**REVIEW OF THE CARBORUNDUM SPECIAL EXPOSURE
COHORT (SEC) PETITION-00223 AND THE NIOSH SEC
PETITION EVALUATION REPORT**

Contract Number 211-2014-58081
SC&A-TR-SEC-2016-0001, Revision 1

Robert Anigstein, PhD
S. Cohen & Associates
1608 Spring Hill Road, Suite 400
Vienna, Virginia 22182

January 27, 2016

Figure A-1. Lognormal Distribution of Uranium Data, Using Regression on Order Statistics (ROS)

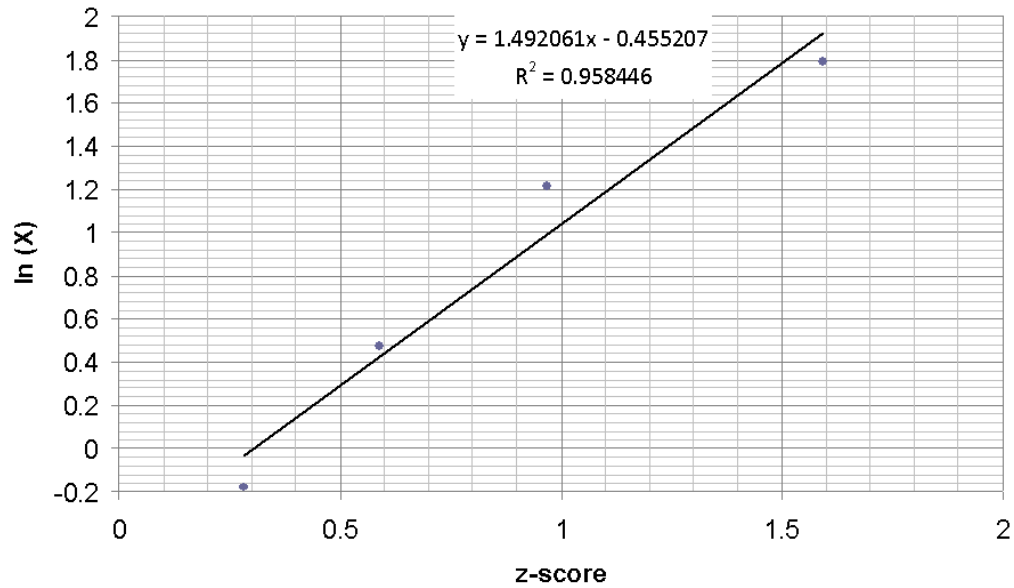
The ER reports that “a statistical analysis of [the uranium] samples results in a GM of 1.666 dpm/m³, a GSD of 2.5111, and a 95th percentile of 7.578 dpm/m³.” We disagree with NIOSH’s statistical methods, which are discussed in greater detail in section 5.2 of this review. Our results for the uranium air samples lead to slightly lower air concentrations than the NIOSH values. We likewise disagree with NIOSH’s statistical analysis of the plutonium dust samples. In this case, our 95th percentile airborne plutonium activity concentration is approximately 16% larger than the NIOSH value. A corresponding increase would apply to intakes during the second residual period due to residues from the second operational period.

The regression of order statistics (ROS) method was used to fit a lognormal distribution to the , including the six nondetect values. A plot of the logarithms of the data versus the normal score for each observation is shown in Figure A-1. (The figure omits the five samples for which no results are listed in the survey report.) The plot also contains a regression line which best fits the plotted data points. The slope and intercept of the regression line are also shown on the figure.

Figure A-2. Lognormal Distribution of Plutonium Data, Using Regression on Order Statistics (ROS)

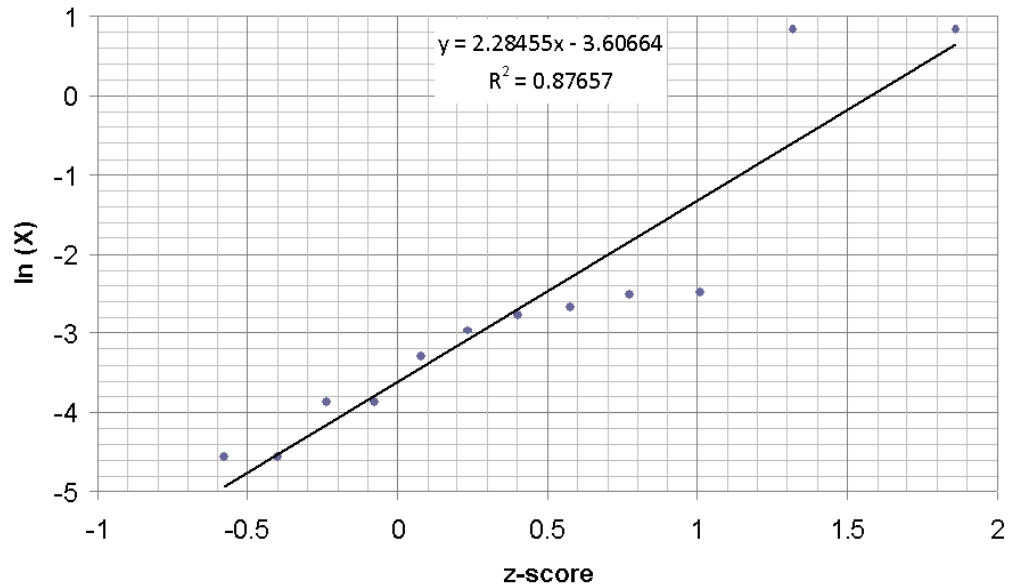
0.0271 dpm/m³, a GSD of 9.821, and a 95th percentile of 1.164 dpm/m³, as compared to the NIOSH values of 0.026 dpm/m³, 9.288, and 1.005 dpm/m³. The 95th percentile obtained by the ROS method is approximately 16% larger than the NIOSH value: The intake by operators is estimated to be 7.651 dpm per calendar day vs. 6.606 calculated by NIOSH. We recommend that NIOSH adopt that ROS value, which is consistent with NIOSH procedures as prescribed by OTIB-19, does not rely on questionable assumptions, and is claimant favorable. The intakes by workers in other job categories, as well as ingestion intakes, should be adjusted accordingly.

Figure A-2 shows a plot of the plutonium sampling data. The value of $R^2 = .8766$ indicates a good fit to the regression line for the lognormal distribution. (The figure omits four nondetect data points included in the distribution.) The characteristics of this distribution are shown in Table 2.
